## SUBMITTAL SUMMARY REPORT MajorSite-000600-2026

<b>PLAN NAME:</b>	Exalt Health Summerfield	<b>LOCATION:</b>	
<b>APPLICATION DATE:</b>	04/09/2026	<b>PARCEL:</b>	47696-000-00
<b>DESCRIPTION:</b>	The project will consist of the construction of a 40-bed inpatient rehab hospital, along with associated utilities, stormwater and parking infrastructure.

# CONSTRUCTION PLANS FOR EXALT HEALTH SUMMERFIELD

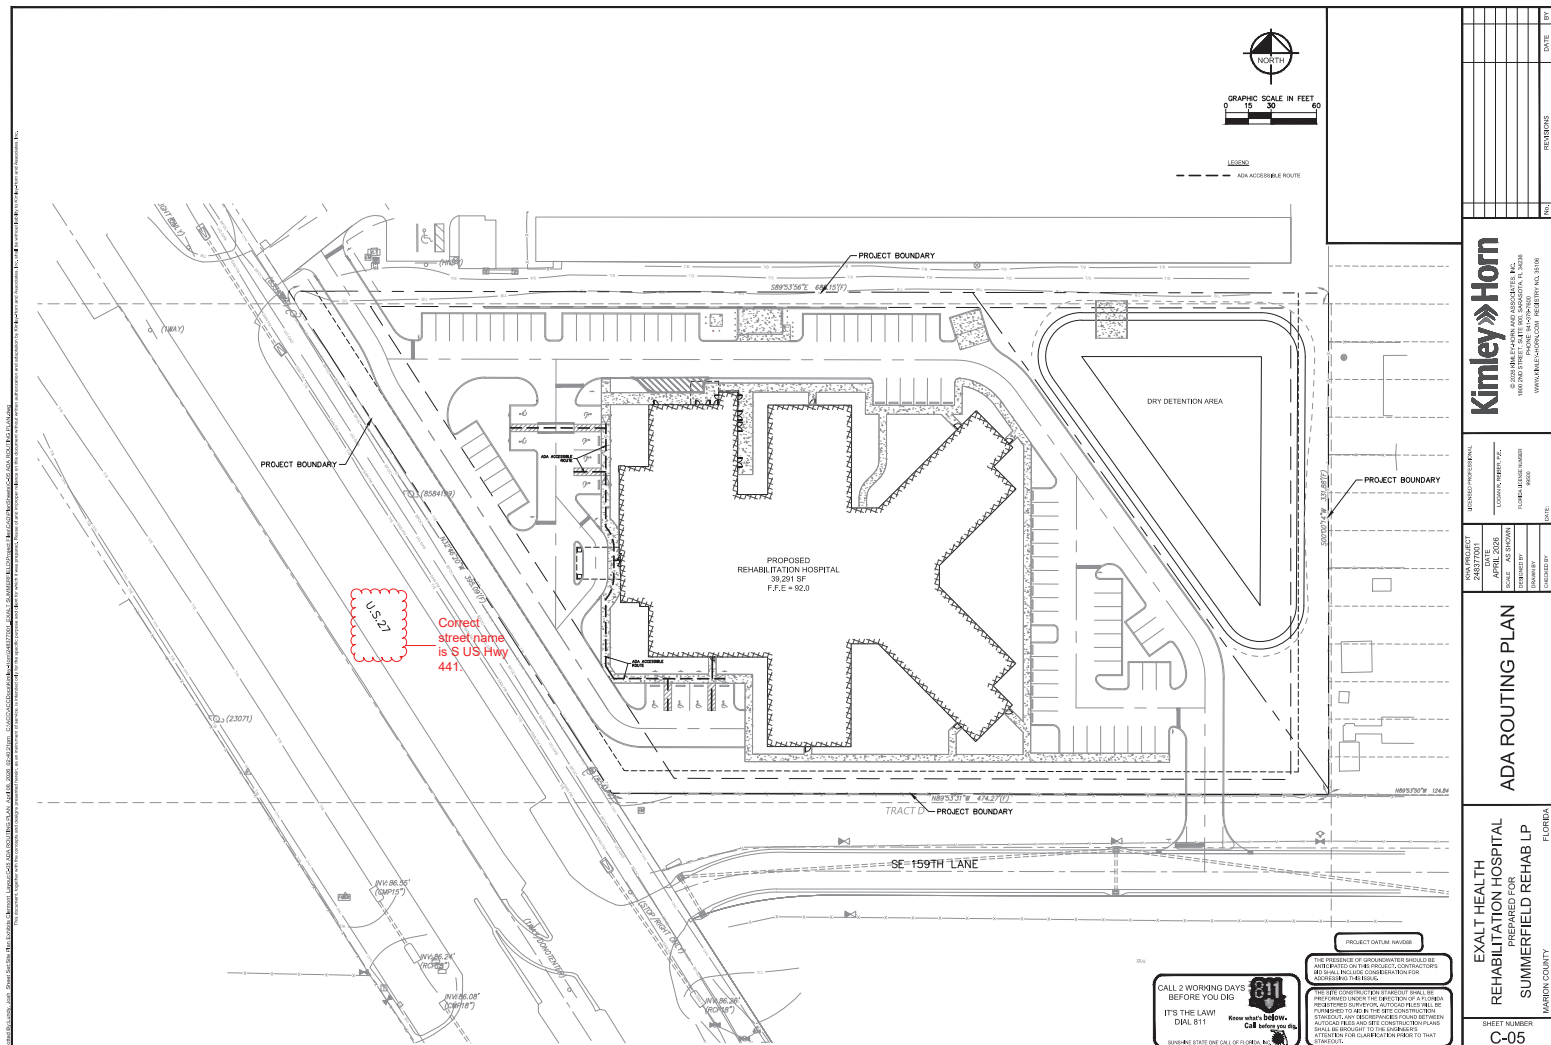
U.S. 27  
 Correct street name is S US Hwy 441.

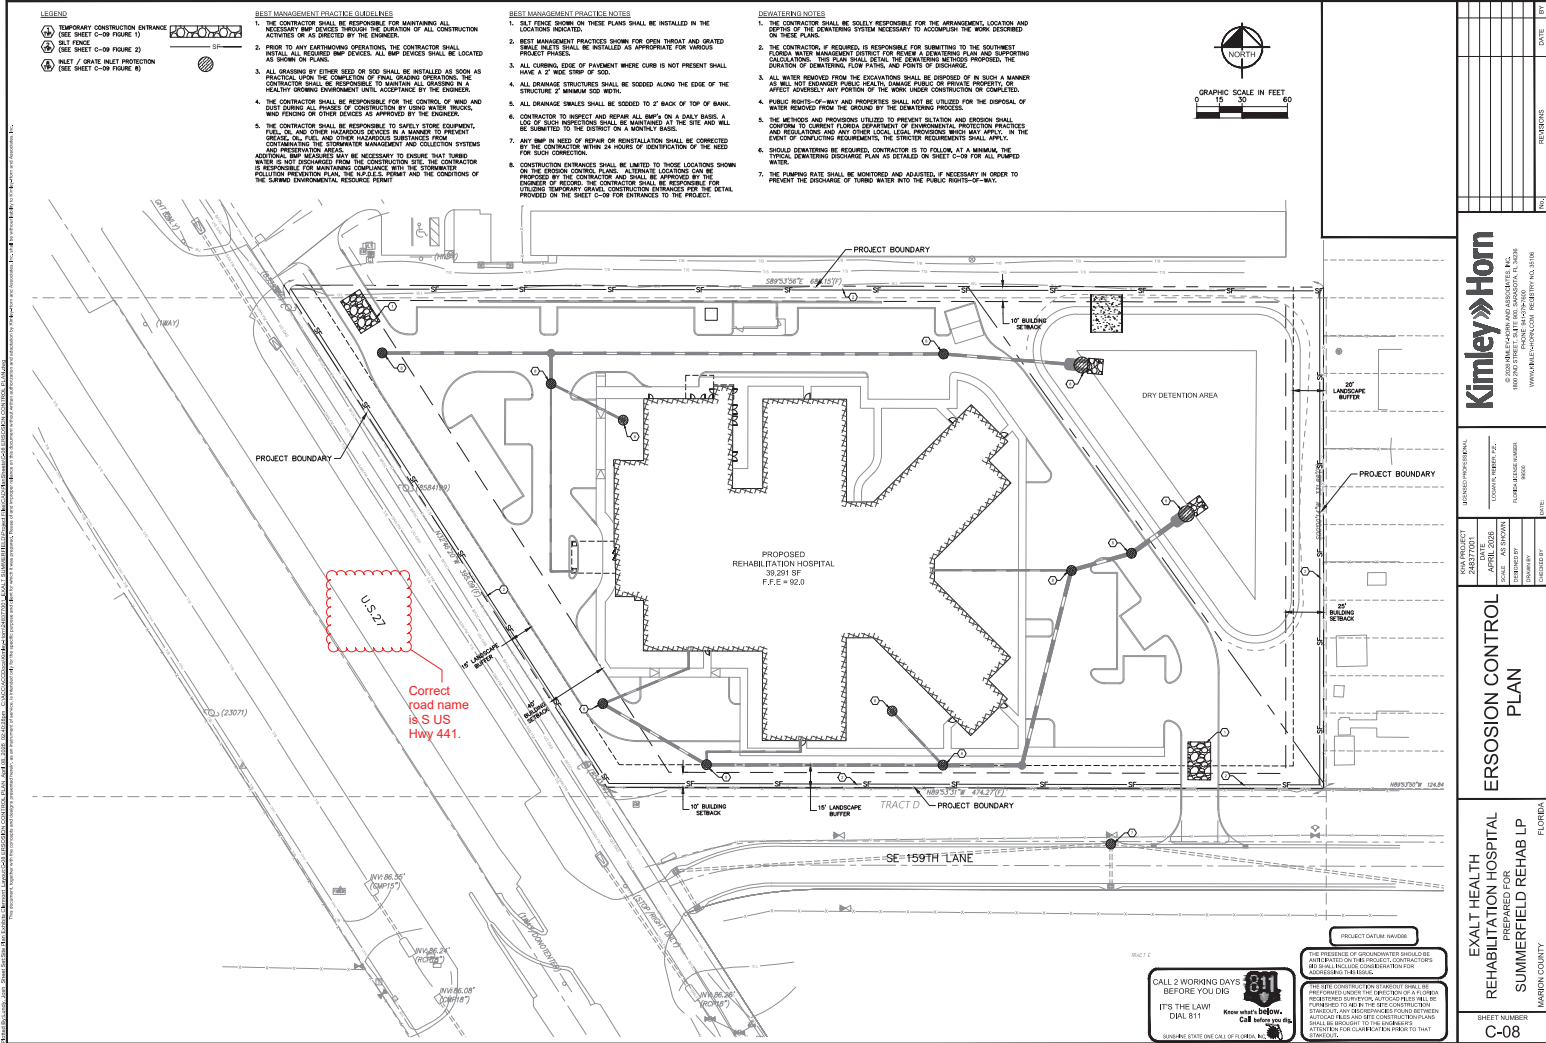
U.S. 41  
 Correct road name is  
 S US Hwy 441.

MATCH LINE SEE SHEET C-07B

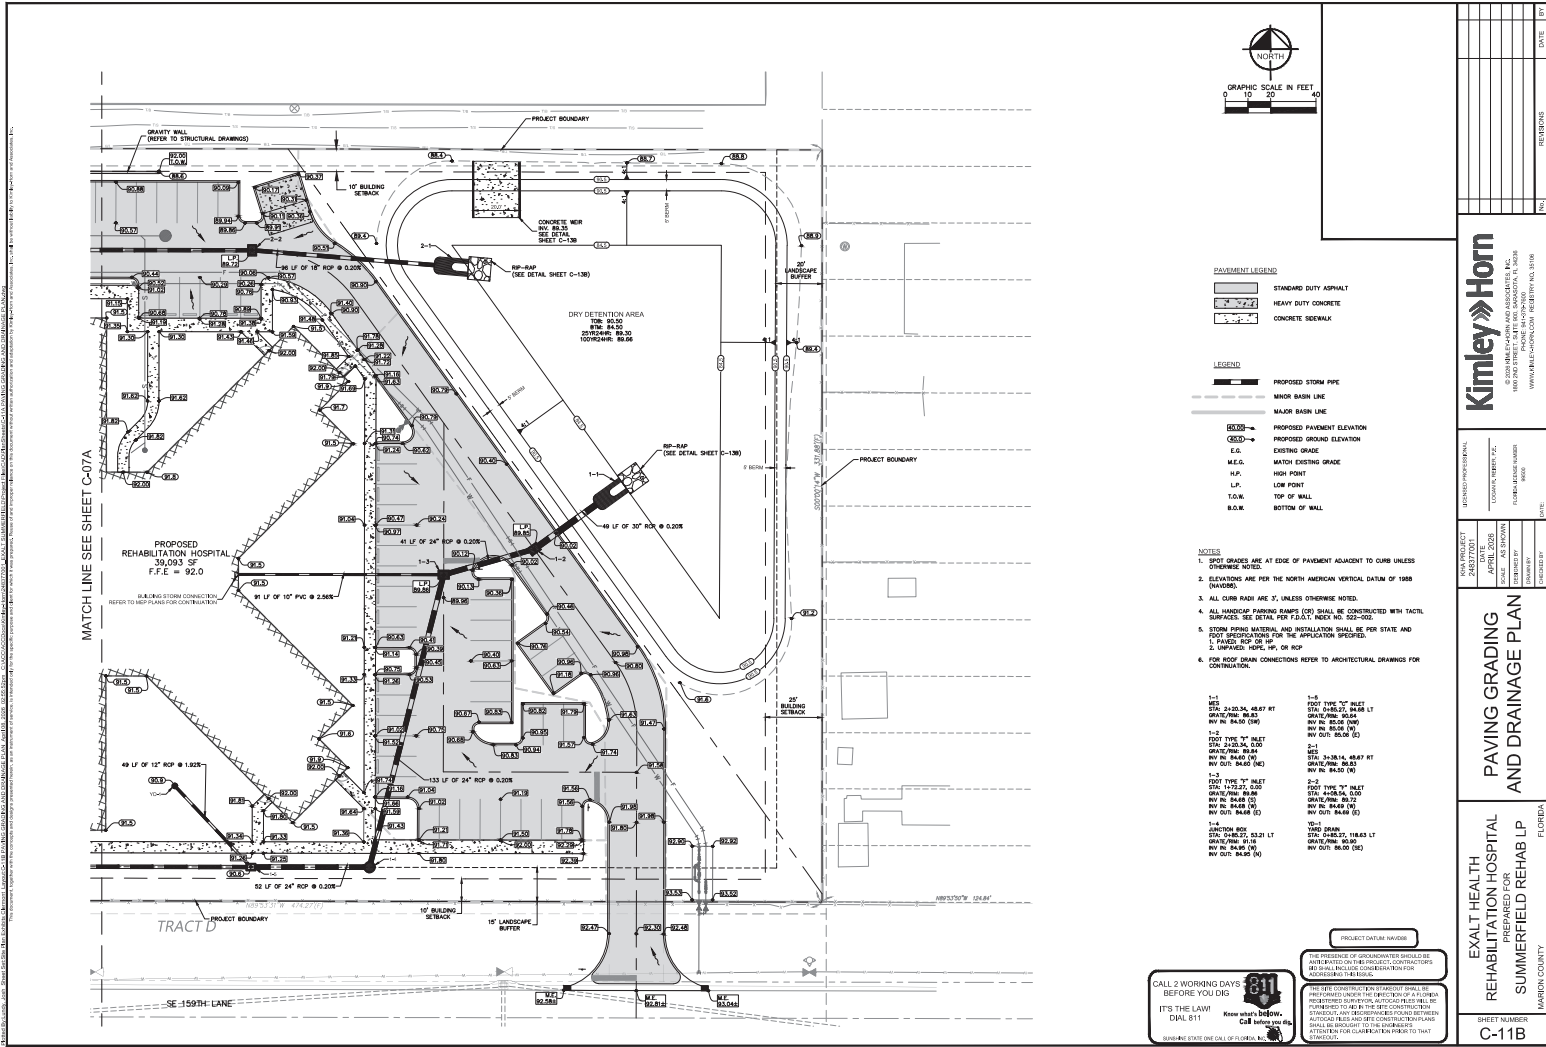
US-27  
 Correct road name is S  
 US Hwy.441.
